# Special Bulletin

# SP22-308.

CHANGE ORDER NO.7 - ABLE Provision. Video Plate Installation  
Prevost vehicles

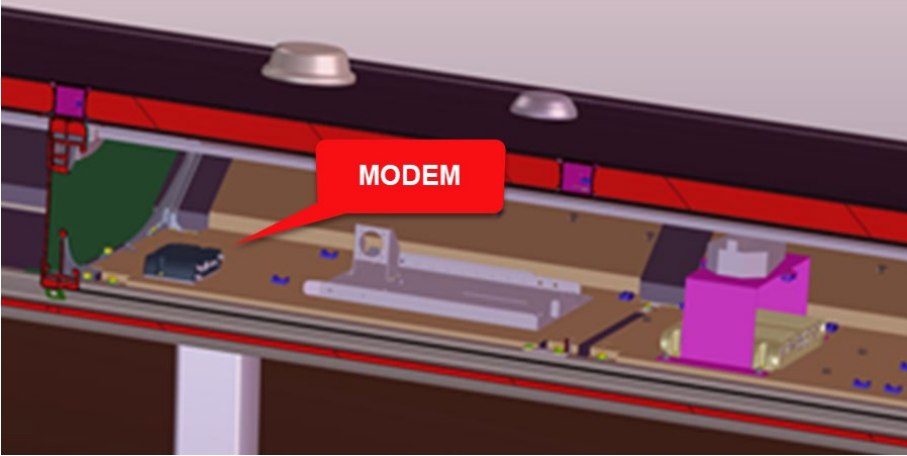
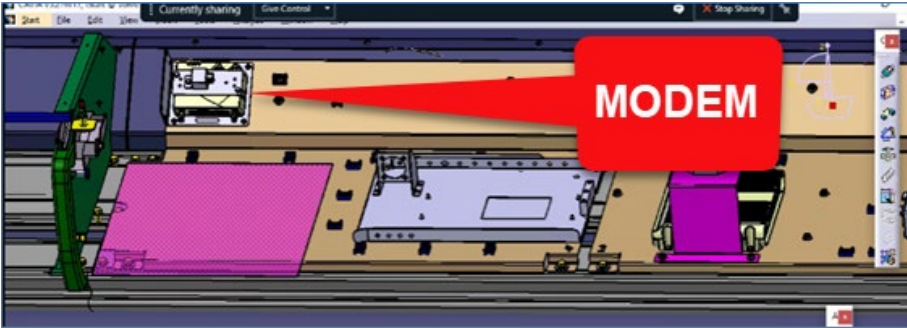
3. Relocate the modem as shown.

Before

After
